## 9-1– 12

### 901.1, 905.1

#### Proposed Change as Submitted

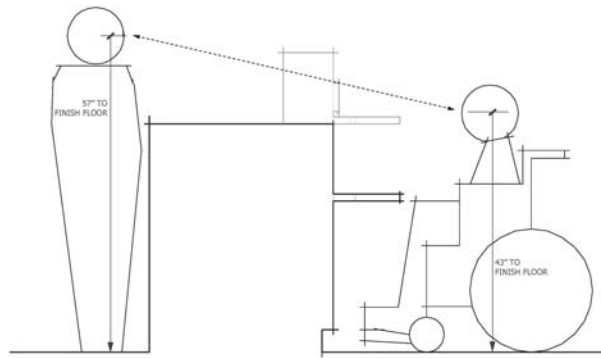
**Further revise the proposal as follows:**

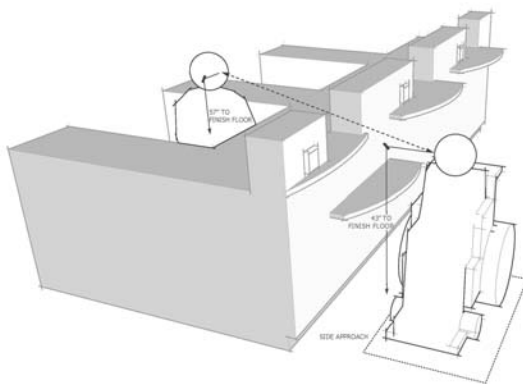
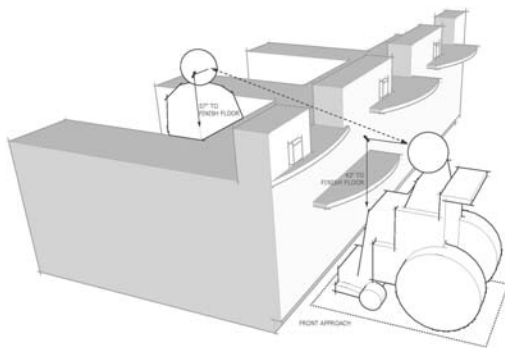
Based upon many discussion points the concerns about sales/service counter heights do not appear to be related to the accessible counter height vs. the employee counter height but rather the visibility/eye site line of an individual using a chair by an employee behind the counter.

Attached are sketches that show the eyelevel of a below average 5'-0" high employee with an eyelevel of 4'-9" working with an individual in a chair with an eyelevel of 3'-7" or what would equate to an individual 3'-11" in height. As this demonstrates an individual using a chair or a standing person of short stature is easily visible and able to work with the employee.

To further this concept I would propose the following amendment to proposal 9-7 and Section 904 that the committee took action on to codify the eyelevel/visibility

**Committee Reason:** The revision removes text that would allow a small shelf for the public rather than a full and equal counter for both the sales personnel and the customers. The revision is based on comment 9-7.1. See also discussion on 9-10-12.
